**RE: NOTICE OF DISAPPROVAL
PHASE II INVESTIGATION WORK PLAN FOR MIDDLE LOS ALAMOS
CANYON AGGREGATE AREA
LOS ALAMOS NATIONAL LABORATORY (LANL),
EPA ID #NM0890010515
HWB-LANL-08-051**

The New Mexico Environment Department (NMED) has received the United States Department of Energy (DOE) and the Los Alamos National Security L.L.C.'s (LANS) (collectively, the Permittees) *Phase II Investigation Work Plan for Middle Los Alamos Canyon Aggregate Area* (Plan), dated November 2008 and referenced by LA-UR-08-7154/EP2008-0558. NMED has reviewed the Plan and hereby issues this Notice of Disapproval.

Figure 3.3-1 Proposed sampling locations at TA-26

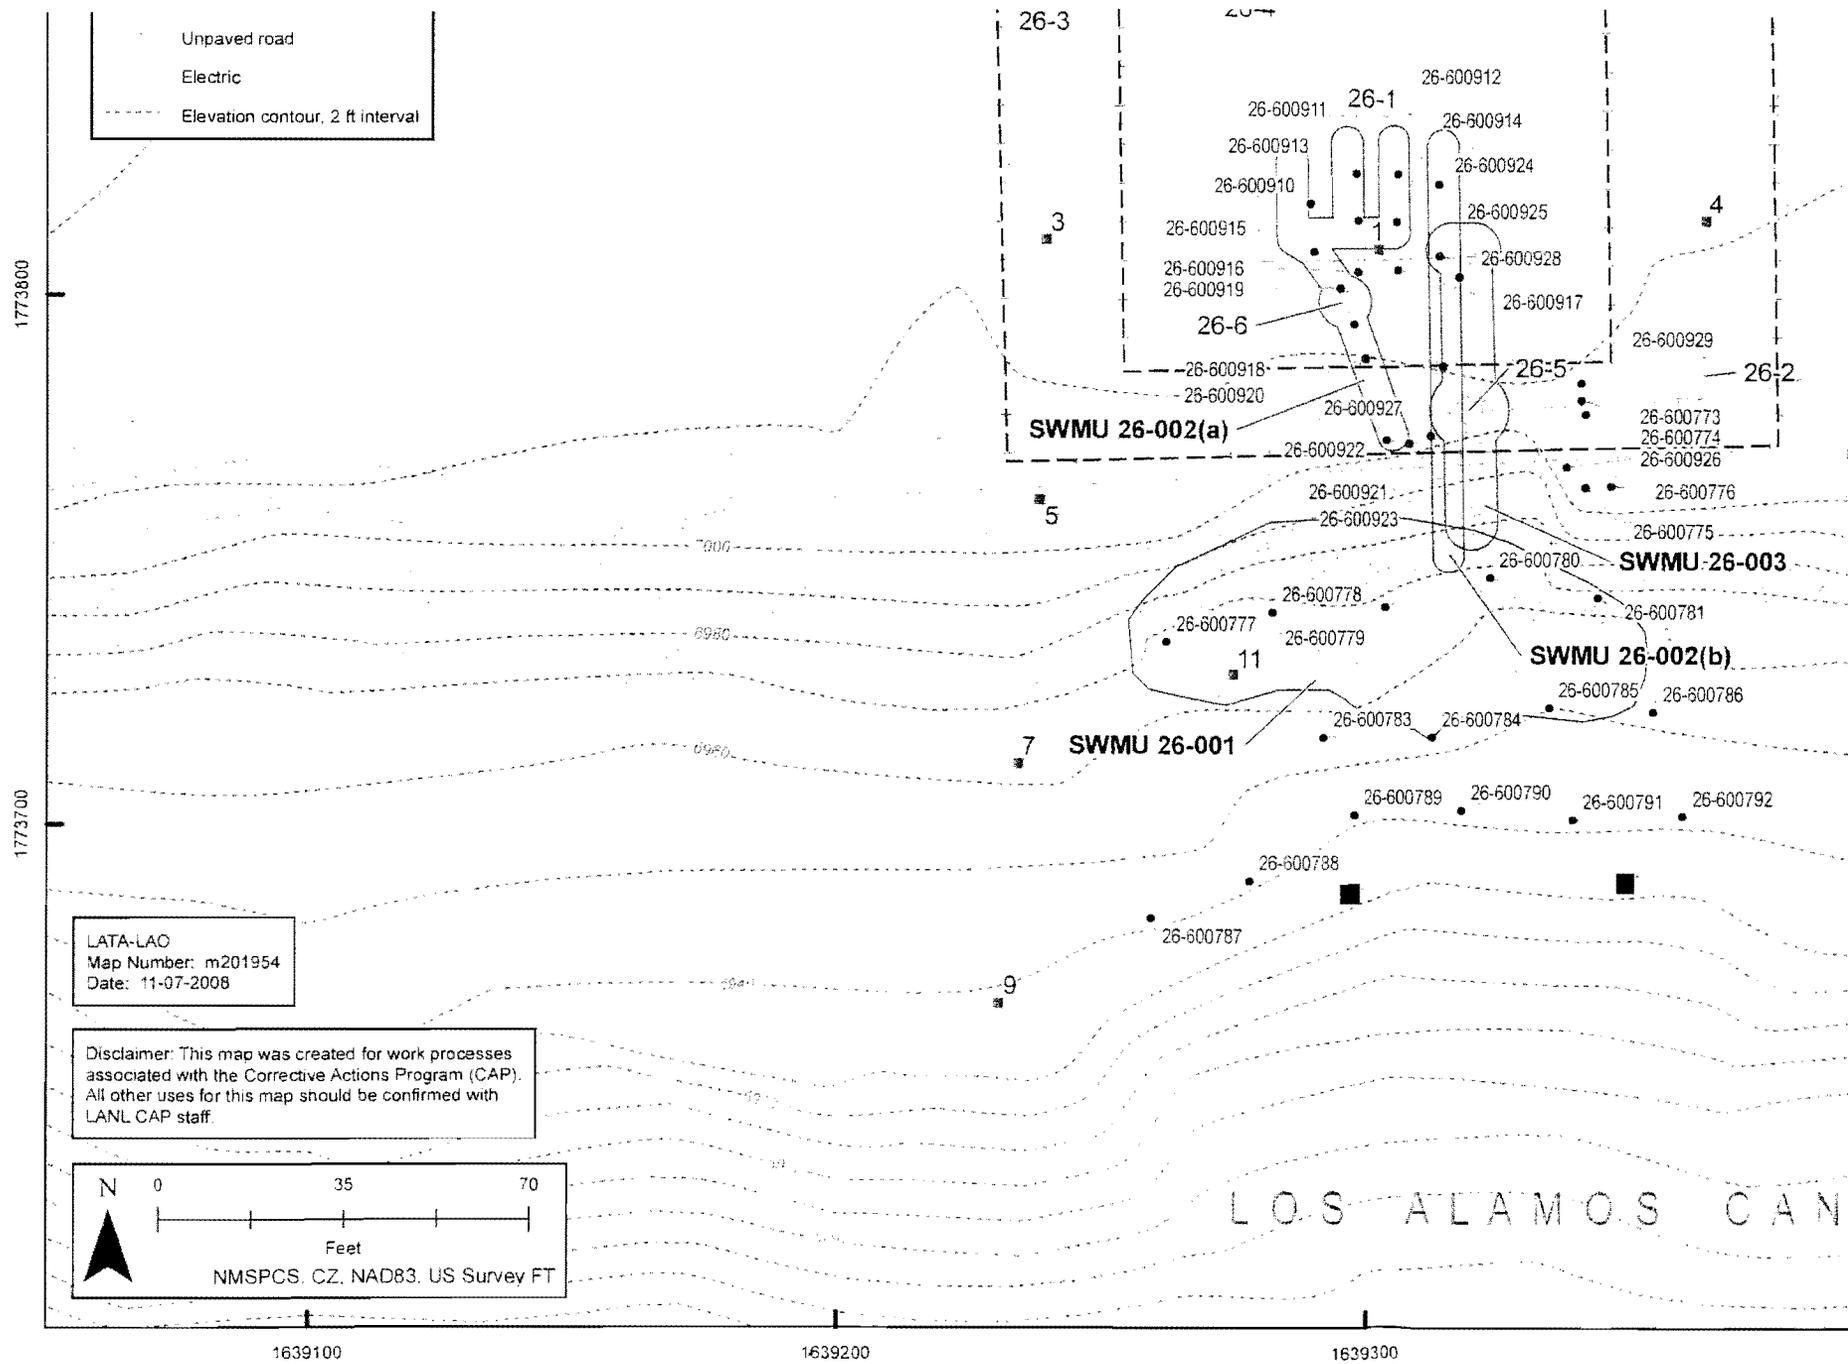
NMED Comment: The reaches are designed to identify contaminants in sediment in the canyons, not to define the extent of SWMUs and AOCs on the mesa top or canyon slope. The Permittees must therefore provide additional or alternative justification supporting the assertion that the extent of contamination is defined at TA-26 or obtain samples from the two additional locations proposed on Figure 3.3-1 (attached). Samples must be collected at the

same intervals and analyzed for the same analytical suite established for the "Canyon Slope" samples in Table 3.3-1 of the Plan.
